Appendix B: CA Coastal Commission
staff report, CDP 9-15-0228 Special
Condition 7

**INDEPENDENT THIRD-PARTY REVIEW OF SONGS' INSPECTION AND
MAINTENANCE PROGRAM FOR THE HOLTEC ON-SITE INDEPENDENT SPENT
FUEL STORAGE INSTALLATION**

JUNE 12, 2020

Figure 4-1 Through Thickness Residual Stress Results after Peening [23]

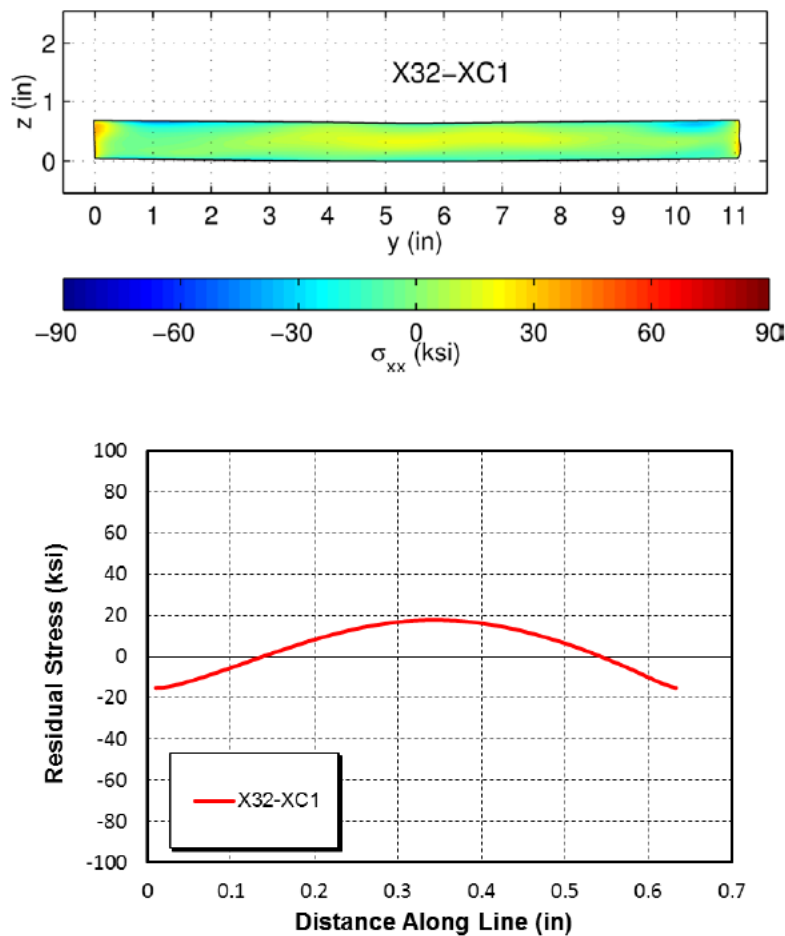
Consistent with the reported depth of compressive stress penetration reported in the SONGS IMP [1] and as shown in Figure 4-1, the residual stress is compressive to a maximum depth of approximately 0.08 in. from the outer surface. The top chart and bottom graph of Figure 4-1 illustrate the stress profile along the length and height of the weld coupon, and the residual stress profile in the hoop direction along the surface of the weld coupon (where 0 in. represents the coupon surface) after peening. Laser peening induces compressive stress on material surfaces and, hence, is an effective method for

Figure 6-2 Metallic Overlay Process for Repairing MPCs at SONGS [1]

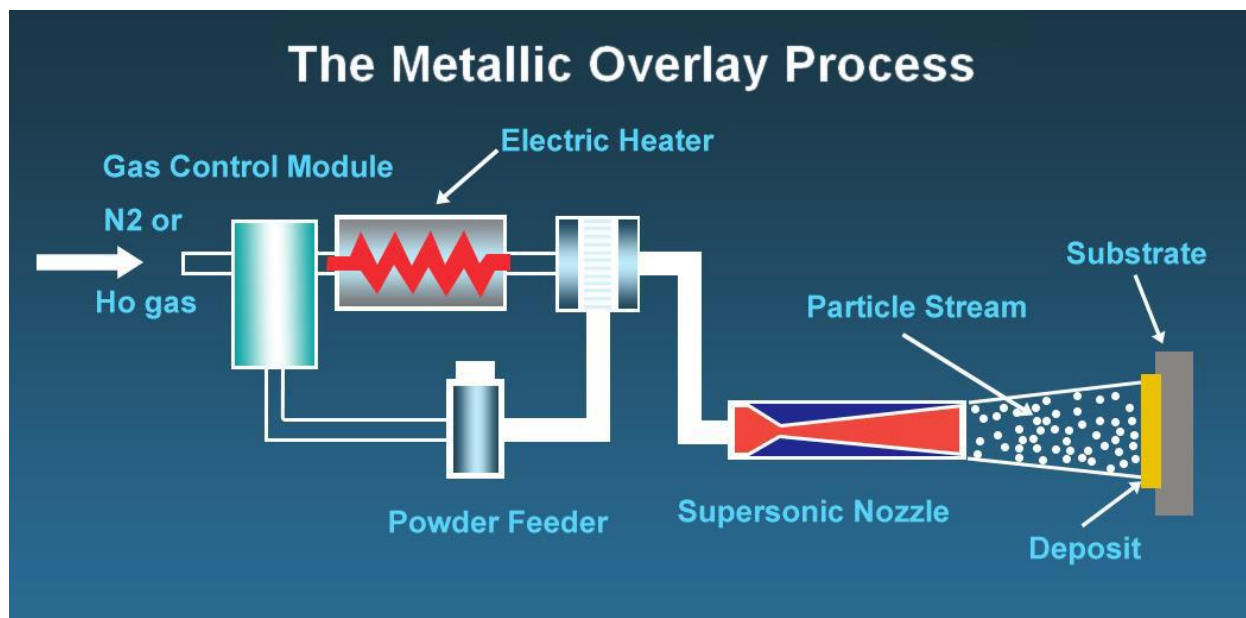
LPI requested clarification on the potential for any adverse effects that result from the metallic overlay methodology, and how the overlay may affect the desired fabrication stresses of the MPC. SCE stated that laboratory tests do not show any adverse effects resulting from application of the metallic overlay process. Instead, the metallic overlay process induces a compressive stress on the base material, which improves the resistance to SCC initiation.

Based on the documentation provided on the metallic overlay process, and SCE's efforts to employ the latest repair methods on degraded MPCs (if it should occur), the proposed repair and mitigation plan for the SONGS Holtec ISFSI canisters is reasonable.

Figure 7-1 Normal Distribution, Three Wear Depth Measurements

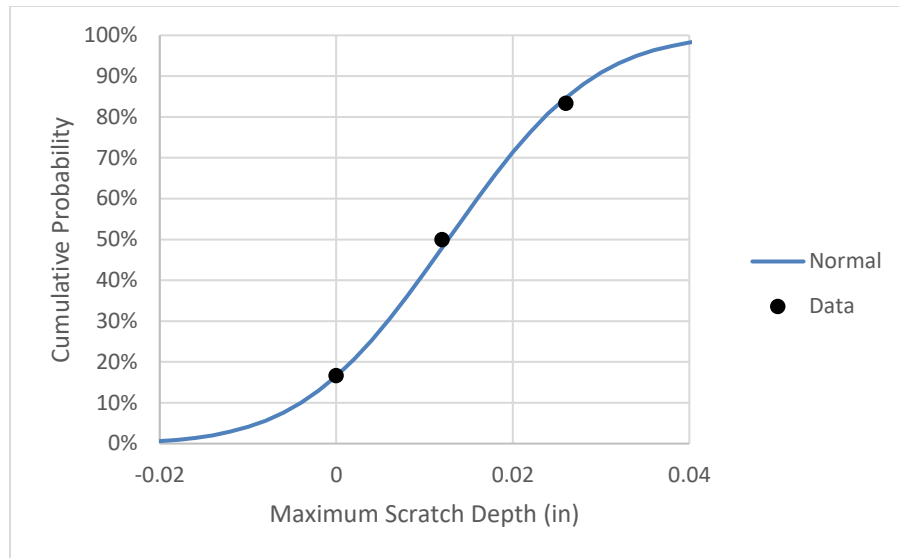
LPI is of the opinion that the Normal distribution is not appropriate to model the maximum scratch depth per canister. In [29], the Normal distribution is based on the initial three measurements of 0.000, 0.012, and 0.026 in., with a corresponding mean and standard deviation (calculated by LPI) of 0.0127 in. and 0.013 in., respectively. In contrast, the Canister Inspection Plan [29] mistakenly reports the mean and standard deviation as 0.013 in. and 0.0125 in., respectively. This was clarified by SCE (as outlined in Attachment G) by conservatively replacing the reported 0.000 in. value with a 0.001 in. value to derive the mean and standard deviation values of 0.013 in. and 0.0125 in., respectively. An LPI plot of the data and fit are shown Figure 7-1.

For the initial three data points shown in Figure 7-1, it is evident that approximately 16.5 percent of the distribution extends into a region of negative or impossible values. If the mean and standard deviation for all 8 measurements had been used, approximately 7 percent of the distribution would still fall below zero. Both sets of data fail the typical “95% range check” [43] for considering the Normal distribution, whereby 95 percent of the fitted distribution needs to make physical sense. Although the primary region of concern is the upper tail of the distribution, specifically at 0.0625 in., having a significant amount of probability assigned to physically impossible negative values deprives the larger maximum scratch depths of probability, thereby underestimating the true risk to the canisters.

In summary, it was recommended the statistical analyses be updated at this time using a more appropriate distribution method, this was done by SCE, as outlined in Attachment G. Additionally, it is recommended that the statistical evaluation be reassessed after the scheduled 2024 MPC inspections, and every time MPCs inspections are performed thereafter to incorporate the additional wear depth data. The revised statistical analyses should include all wear depth data, and employ extreme value statistics to predict 95 percent probability bounding flaw depth, with 95 percent confidence level for the entire MPC population and not just a single canister. The number of canister inspections and inspection frequency should be revised (as appropriate) based on the revised statistical analyses. Scratch depth data from future inspections will likely reduce the probability in a meaningful way provided, of course, that the maximum scratch depths stay within the range of previous depth measurements.

Figure 4-1.

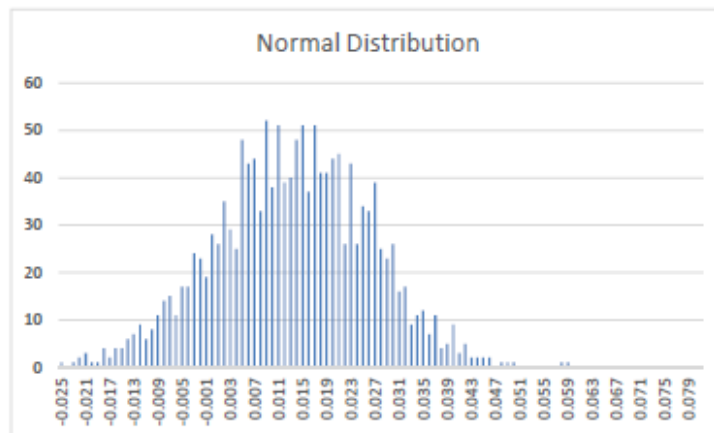
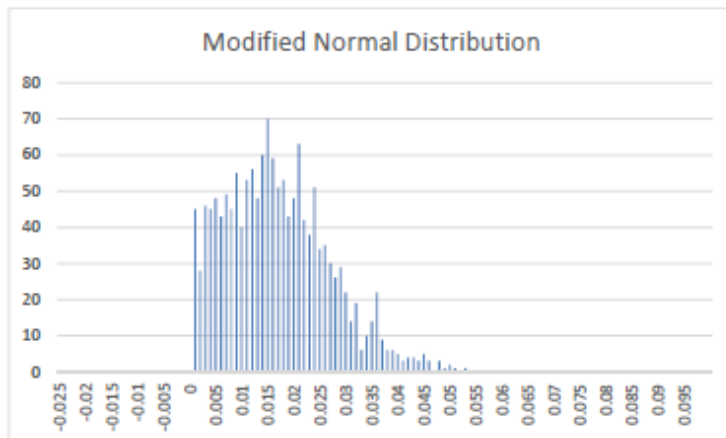
One concern with selecting a normal distribution for modeling the deepest scratch random variable is that measured scratch depth is always a positive number and the left tail of the normal distribution will include some negative numbers making the probabilities associated with a standard normal distribution non-conservative. To determine whether use of a standard normal distribution is acceptable considering the effect of the negative left tail values, a simulation was run using 1500 trials to produce a modified normal distribution that forces all scratch depth measurements to be positive numbers. In the simulation, every time a negative value for scratch depth occurs, the simulation selected another normally distributed random number to replace the negative value until a positive value appeared. The results of simulations for the standard normal distribution and the modified normal distribution for the mean scratch depth (13 mils) and standard deviation (12.5 mils) associated with the three measured canisters are compared below.

As described in the attached April 15, 2019 MPR white paper, *Canister Inspection Plan*, the concern that assuming a normal distribution would be non-conservative since a normal distribution would allow negative scratch depths, was previously addressed by performing a sensitivity analysis that showed the effect of the slight non-conservatism introduced by the negative values in the left tail of the normal distribution did not have a significant effect on the maximum scratch depth statistics.

Figure 2 – Canister #72 Detailed Pictures and Profilometry

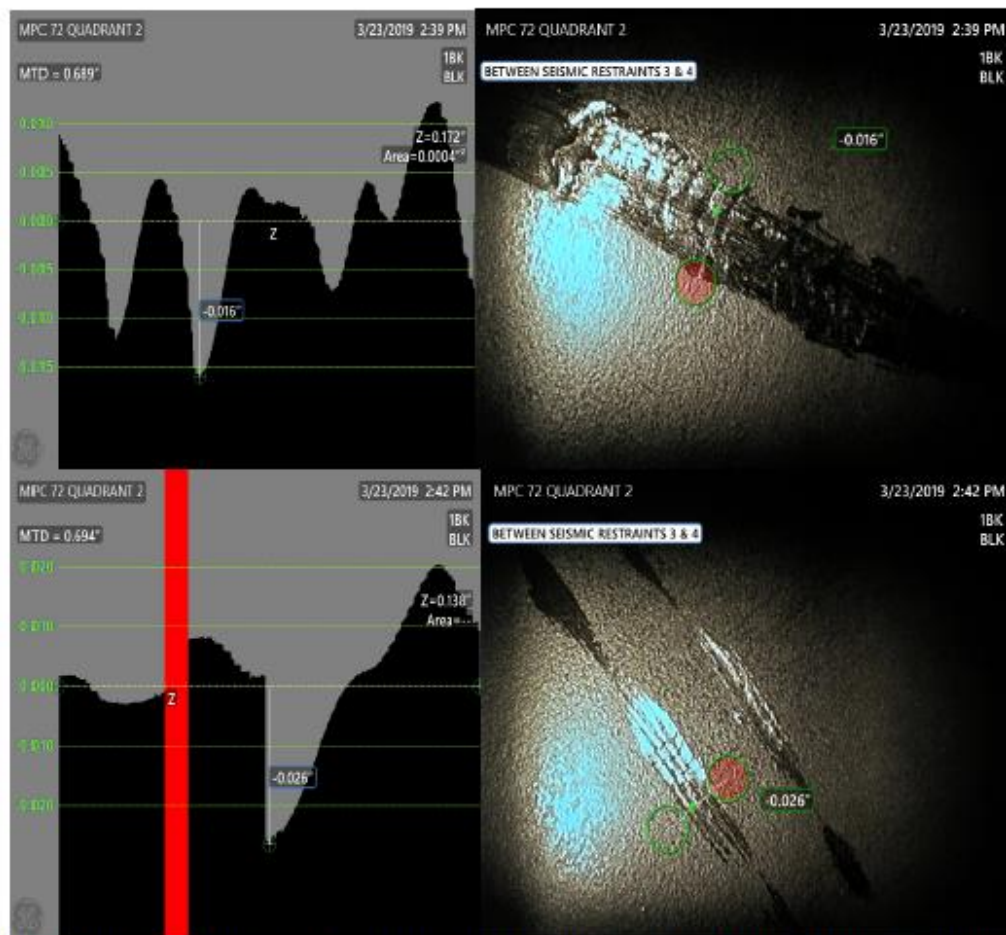
- 1) Please provide more information regarding the 2019 canister inspections, MPC scratch profiles, and number and location of scratches.

As an example, representative photos of two scratches from canister #72, with associated profilometry, are shown in Figure 2 below. (These scratches are identified in the highlighted entries of Table 1 above.) Both of these scratches were caused by interaction with a seismic restraint.

The profiles generally show raised metal adjacent to each depression consistent with galling of austenitic stainless steel. No metal removal was observed. No metal debris was found in the bottom of the VVM or at the contact points on top of the shield ring or seismic restraints.

The deeper measurements were only observed in localized areas of galling. Galling occurs when two austenitic stainless steel surfaces wear, and is a different phenomenon than the scratching modeled by the FEA. Galling is self-arresting because the material is not removed, just rearranged.
